Title:	RN Thermal	Version:	v5.5.26	Date:	042020
Product:	Hikvision Thermal Cameras	Build:	200330	Page:	1 of 2
Action Required:	None, Information Only

The latest firmware is v5.5.26, build 200330. The main upgraded content is as follows:

Figure 1, Configuration > Basic Event

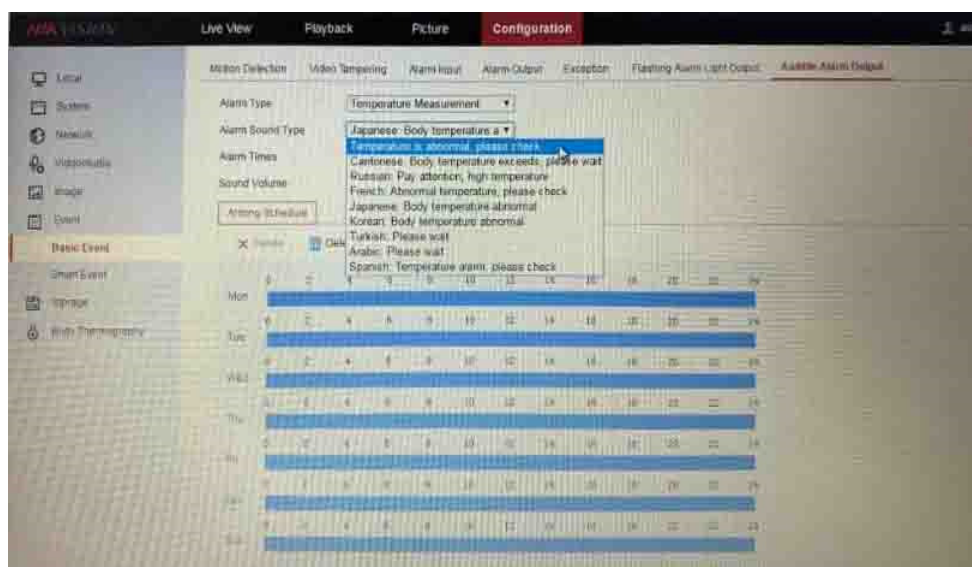
- Change to forehead thermometer to show the highest temperature on the forehead area passively.
- Reduced false alarms caused by corners of the eyes, corners of the mouth, and hot objects in the background.

- PA device alarm voice supports the selection of other languages (Japanese, Korean, Arabic, Turkish, Russian, French, Spanish, Italian)
- Added distance measurement mode:
 - **Self-Adaption Mode** calculates the temperature compensation value according to the pupil distance when a face is detected.
 - **Fixed Distance Mode** calculates the temperature compensation value according to the fixed distance when the side face exceeds one second.
